**ALERT SERVICE BULLETIN**  
**Bell Helicopter** **TEXTRON**

NO. 407-07-80

DATE AUG 27, 2007

**SUBJECT:** TAILBOOM ASSEMBLY 407-030-801-107, AND 407-530-014-101/-103, NEW INSPECTION REQUIREMENTS.

Figure 3. 100 Hour inspection of tailbooms 407-530-014-101, 407-530-014-103 and 407-030-801-107 (Sheet 1 of 7).

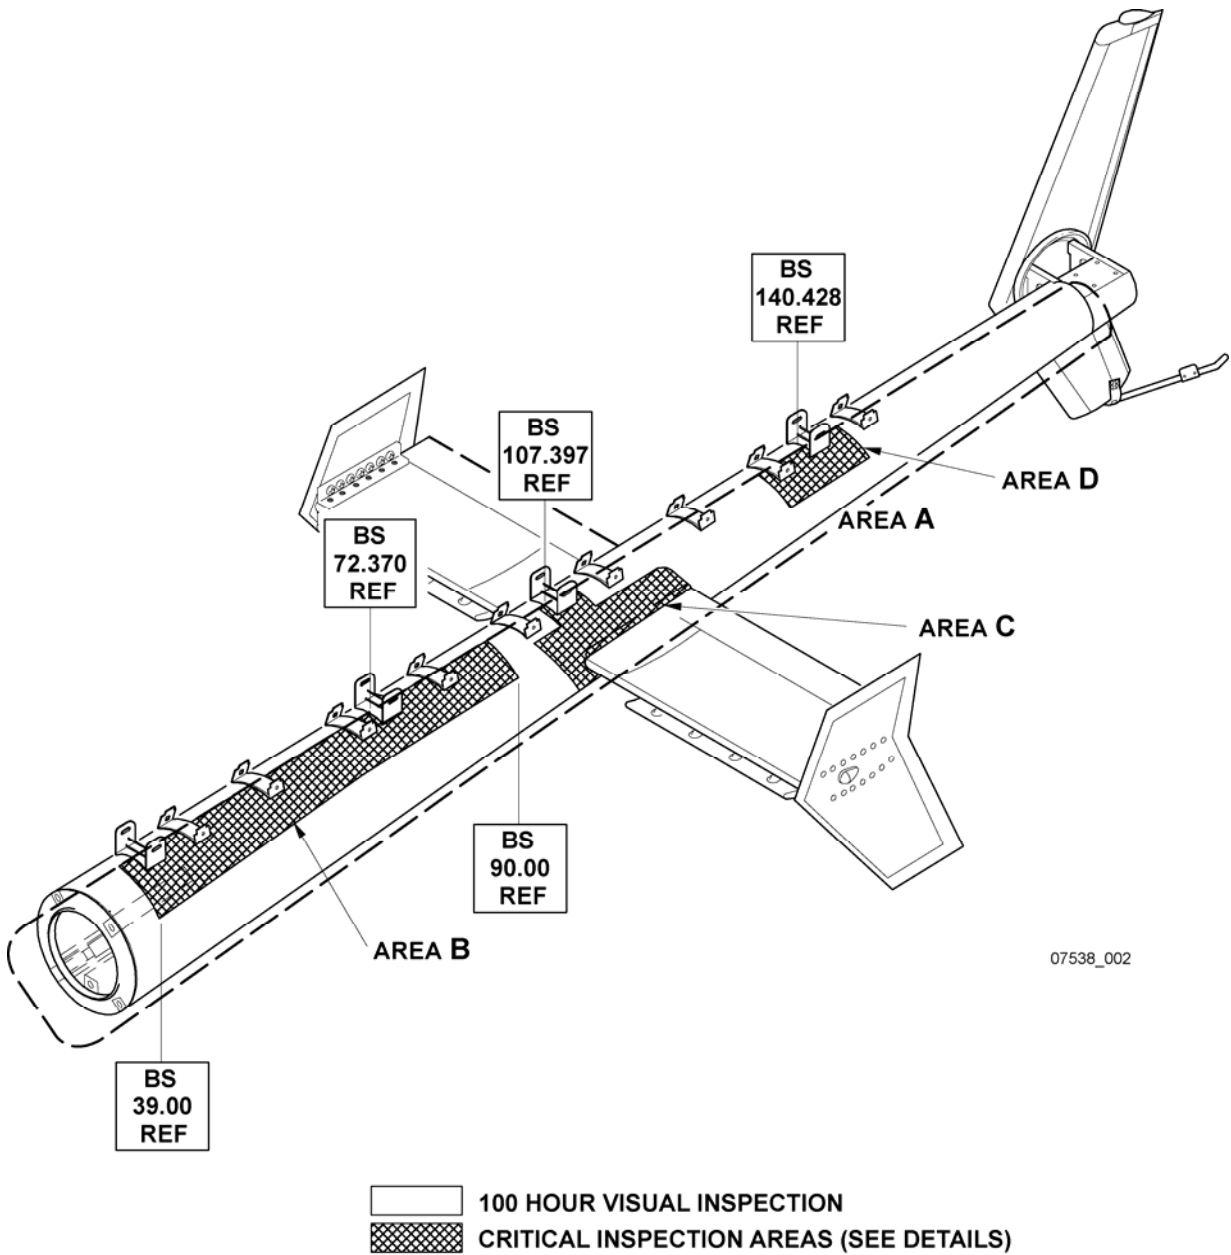
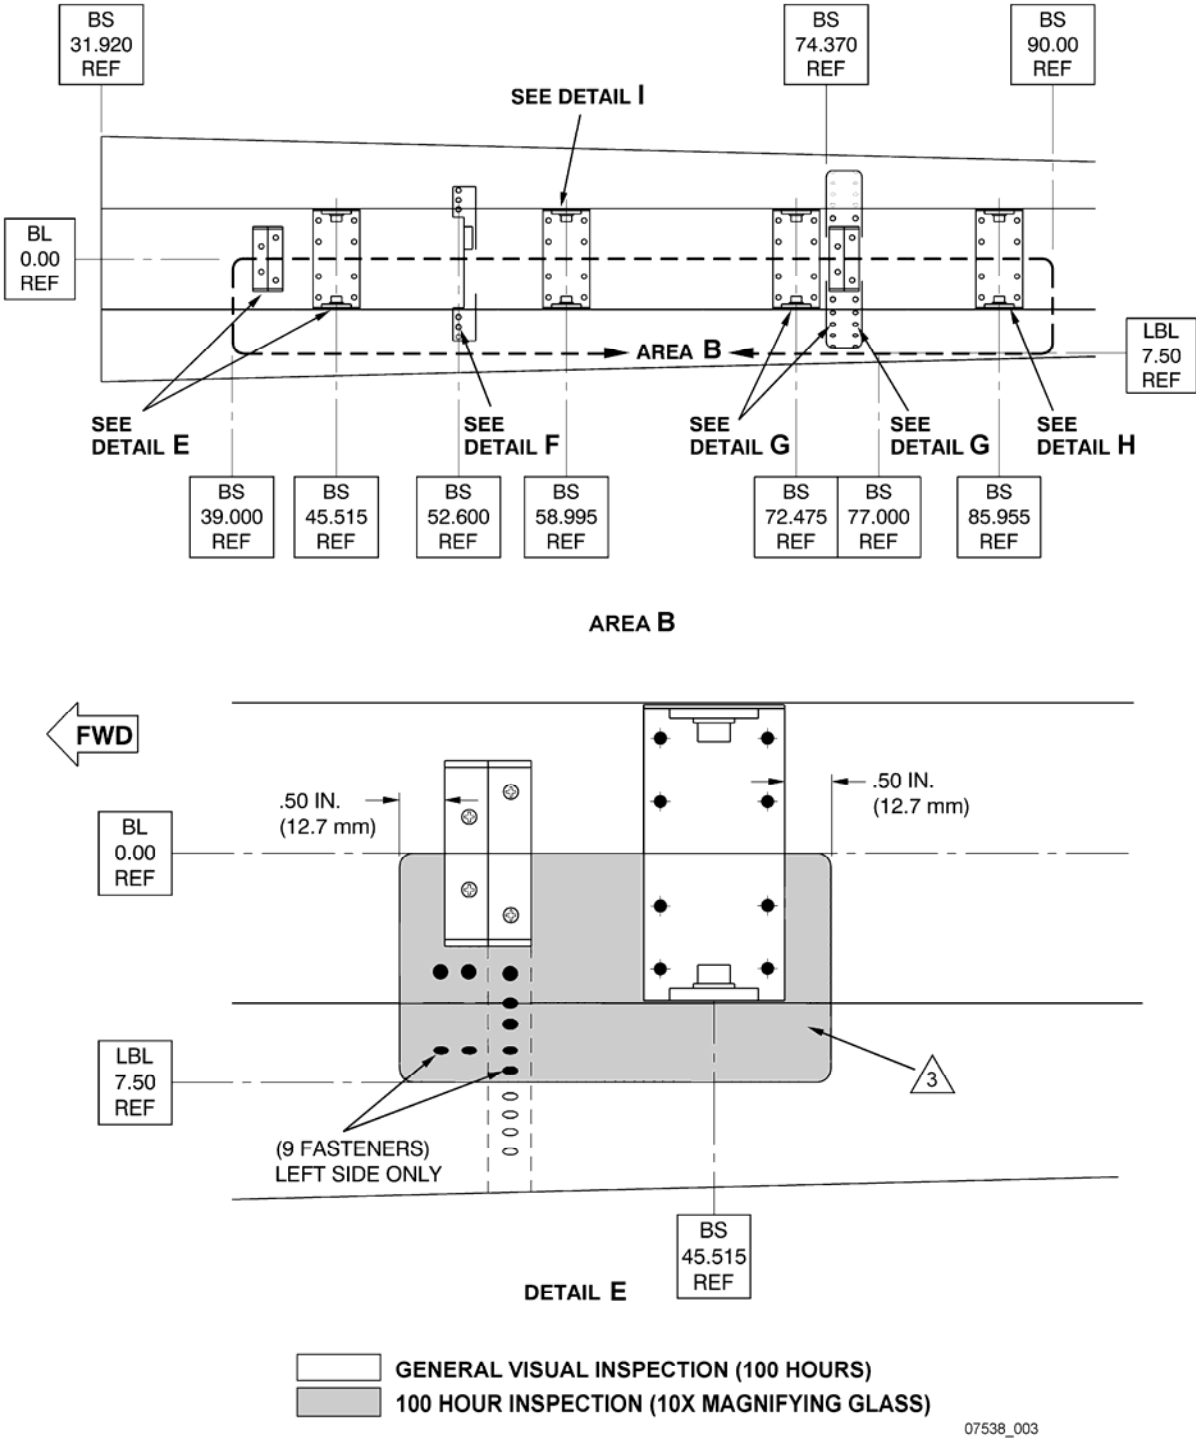
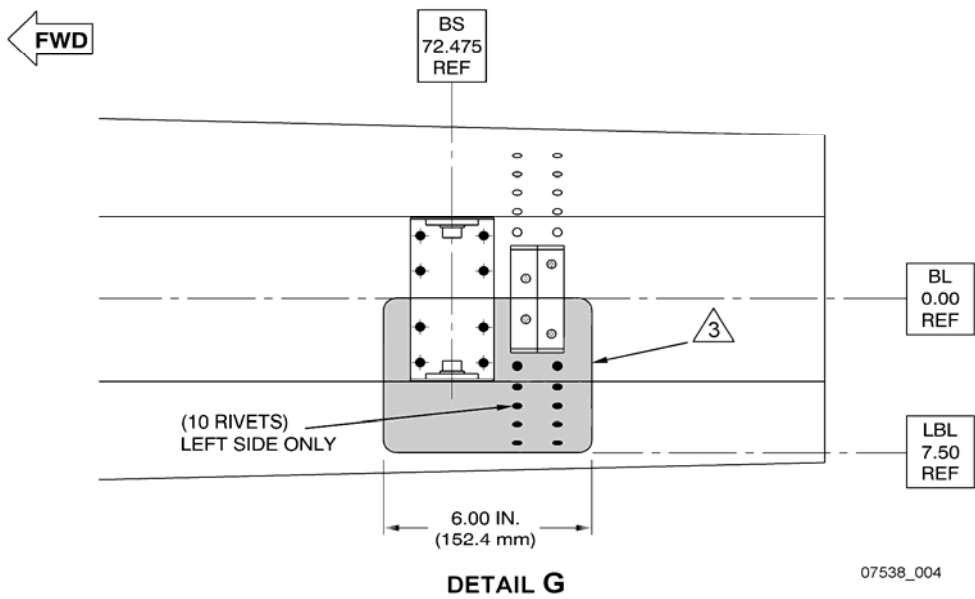
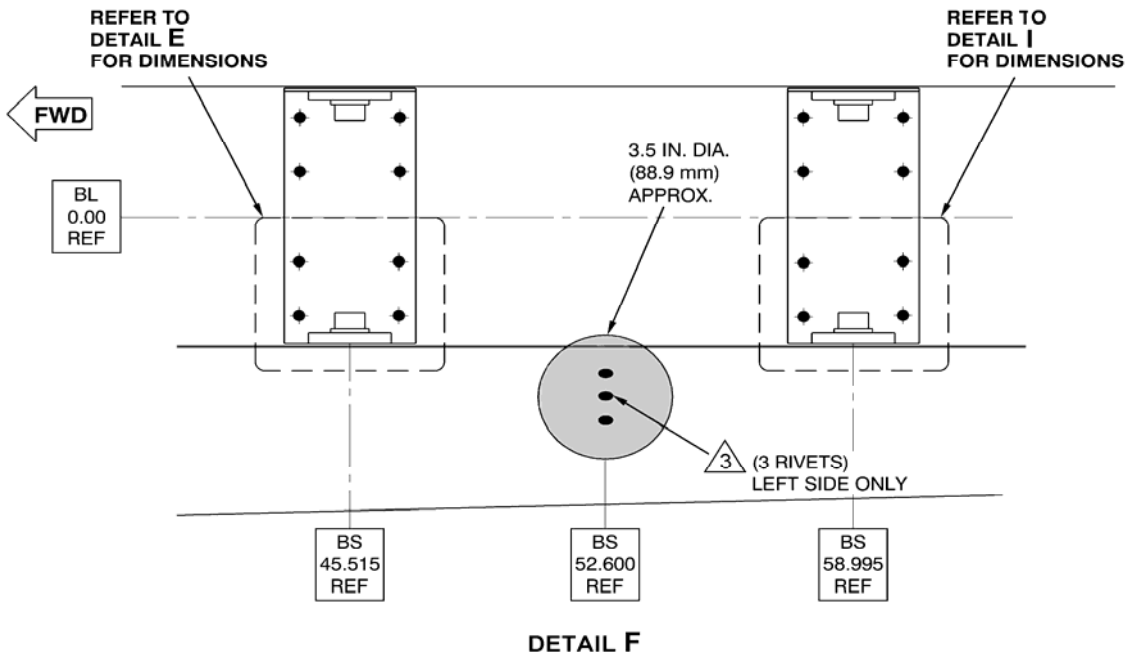
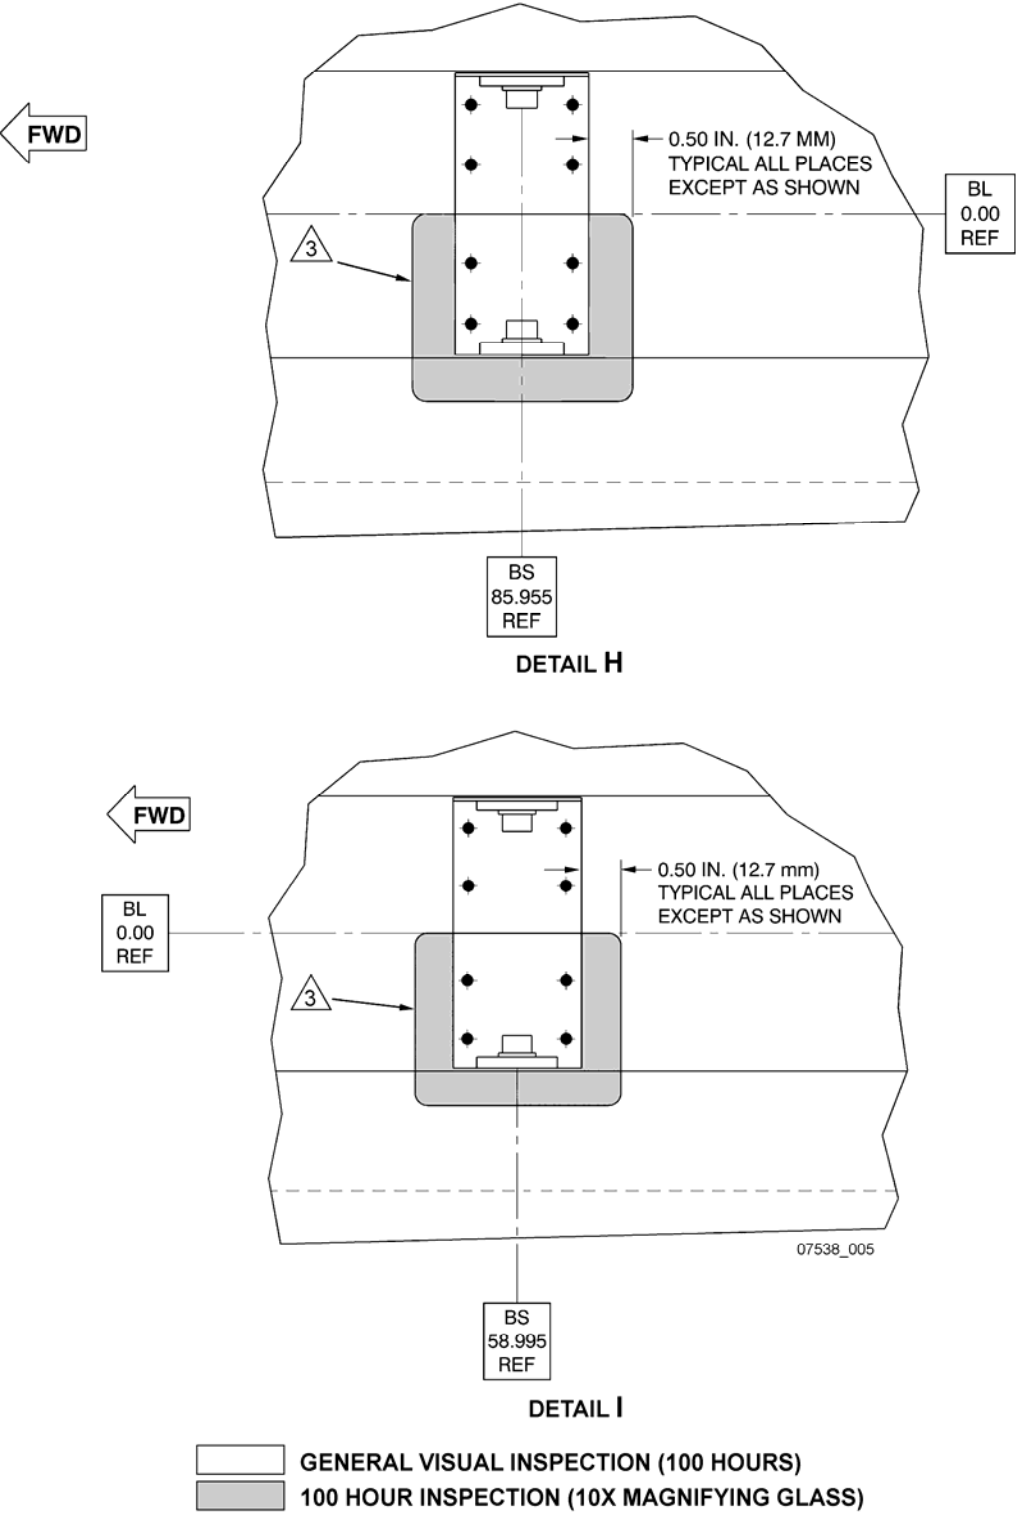
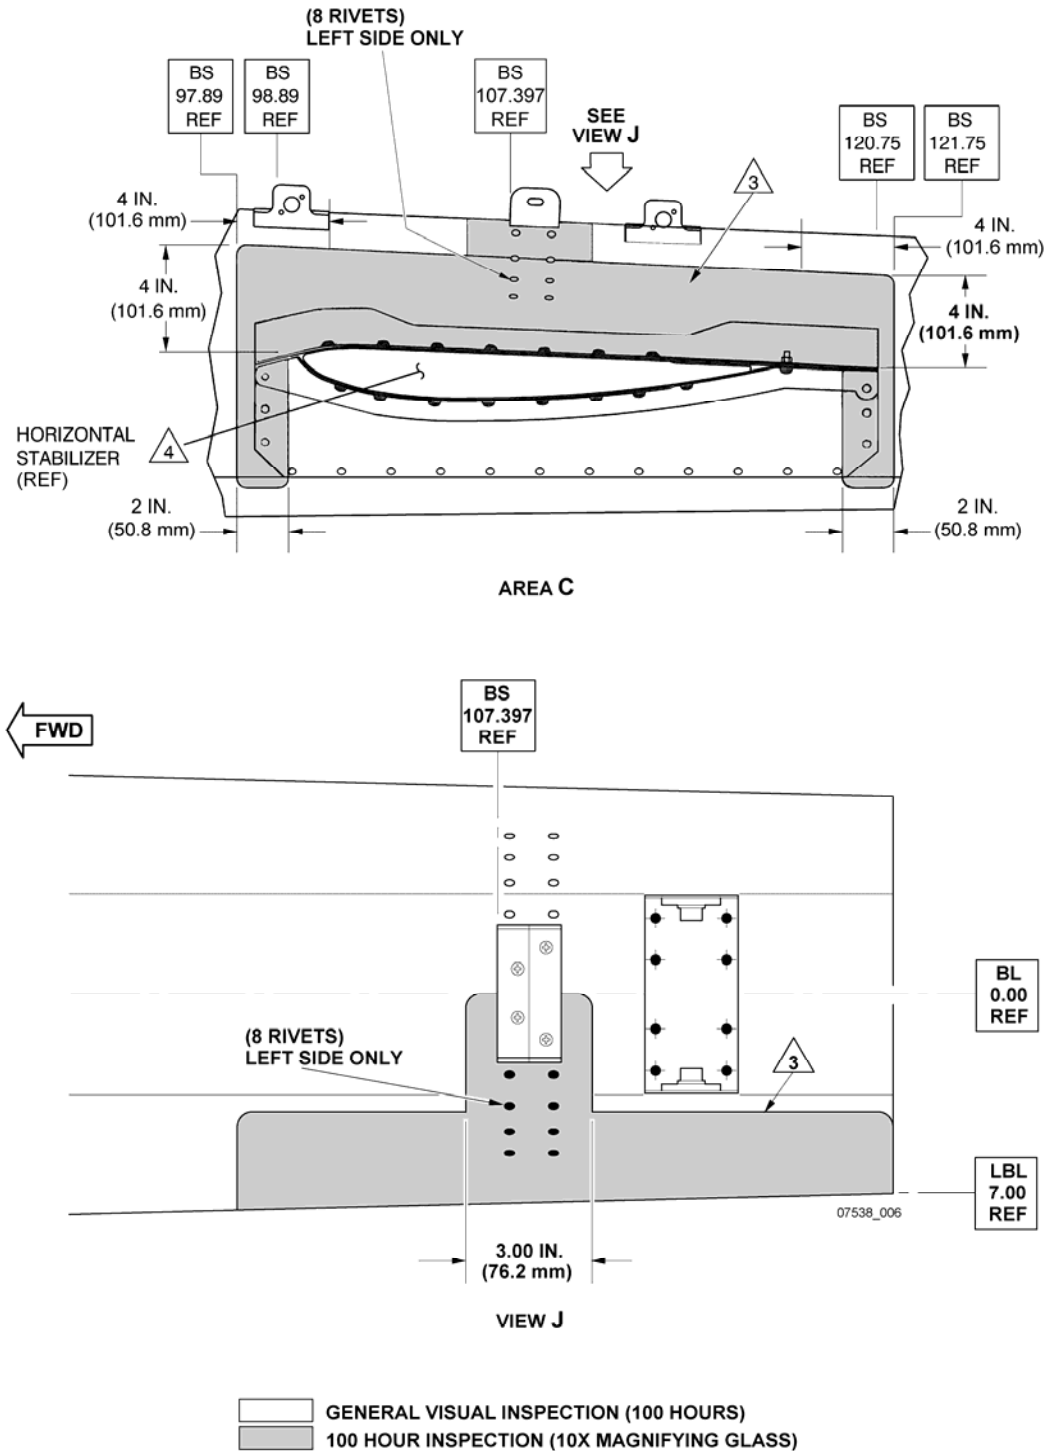
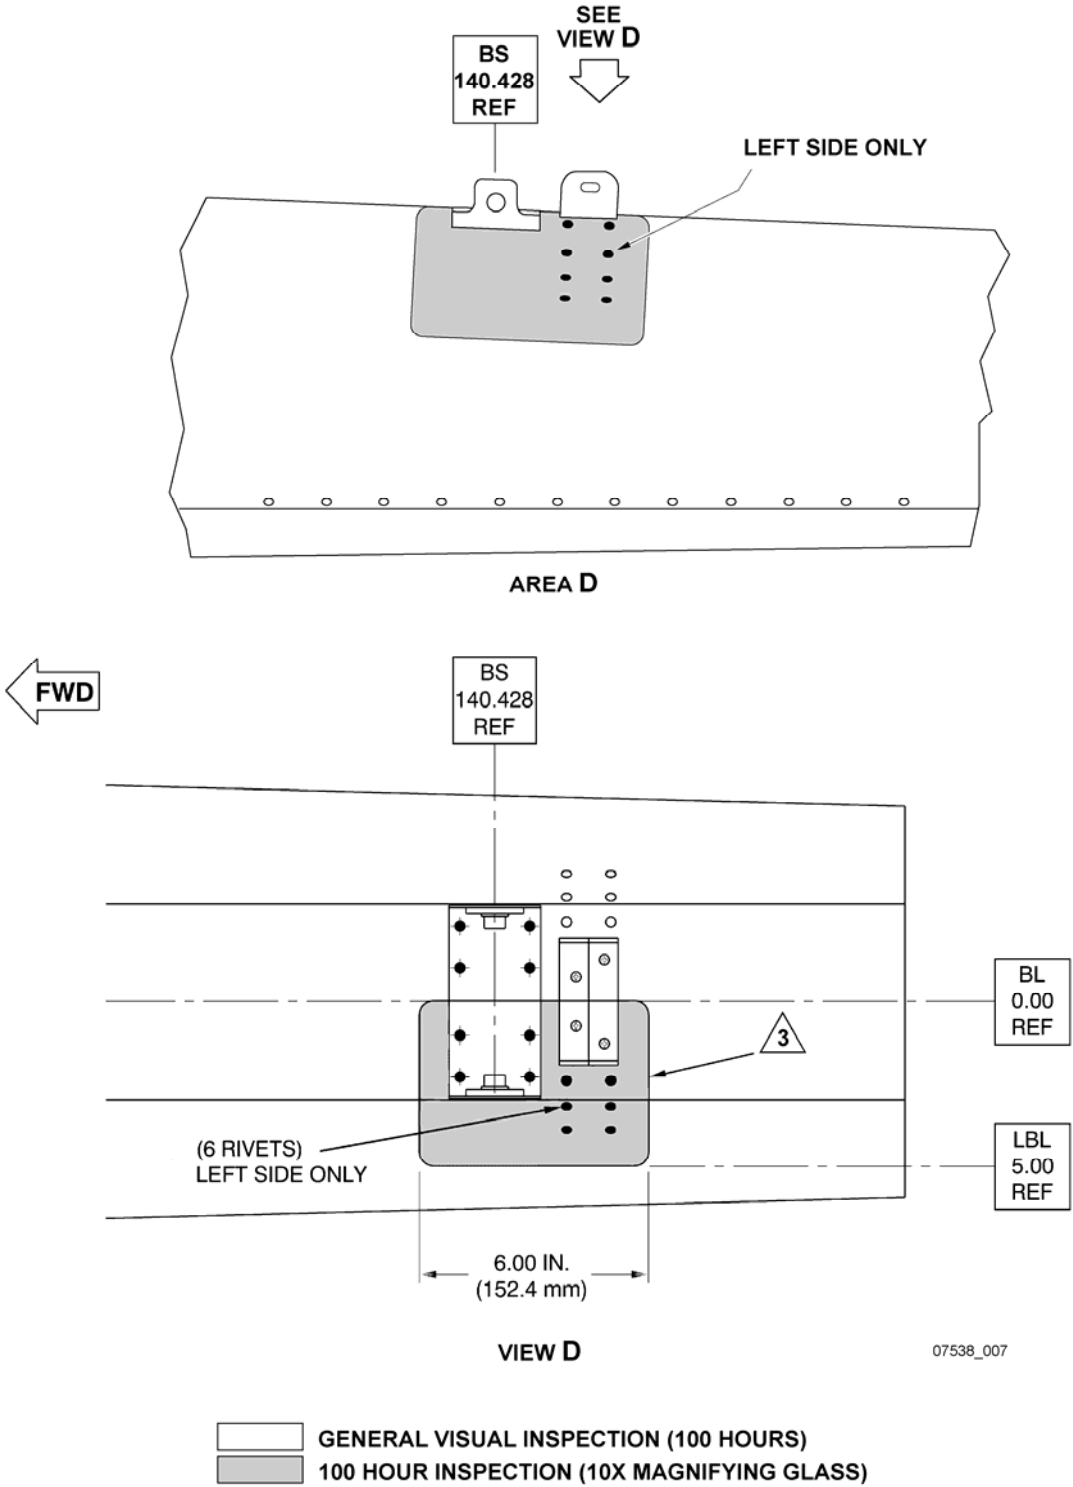
3. Examine the complete tailboom assembly P/N 407-530-014-101/-103 or tailboom 407-030-801-107 every 100 Hours of operation for general condition, loose rivets, cracks or any other type of damage. Pay close attention to Area "A" indicated in Figure 3 for the left side of the tailboom.

4. Inspect for loose rivets in region shown in Figure 3, Area "A" and especially in Details "E", "F", "G", "H", "I" and Views "D" and "J". If a loose rivet or fastener is found, remove it per standard practices and inspect hole for cracks using a

5. If no loose rivets or fasteners are found loose, use a 10X magnifying glass and examine tailboom skin at edge of mating supports/brackets and around fasteners shown in Figure 3, Details "E", "F", "G", "H", "I" and View "D".

6. On left side of tailboom, use a 10X magnifying glass and examine tailboom skin at edge of mating supports/brackets and around fasteners shown in Figure 3 Area "C" and View "J".

1. Inspect the complete tailboom assembly for general condition.
2. On the left side of the tailboom only, do a detailed inspection of all areas shown for cracks in the tailboom skin and loose rivets. Do not remove the paint or primer. If a loose rivet is found, remove rivet and inspect hole for cracks using a 10X magnifying glass. If no cracks are found, install correct diameter rivet. Do not exceed maximum diameter prescribed.

Use a 10X magnifying glass to inspect for cracks in tailboom skin and around fastener heads as indicated in area shown in Detail E, F, G, H, I, View J, View D and Area C.
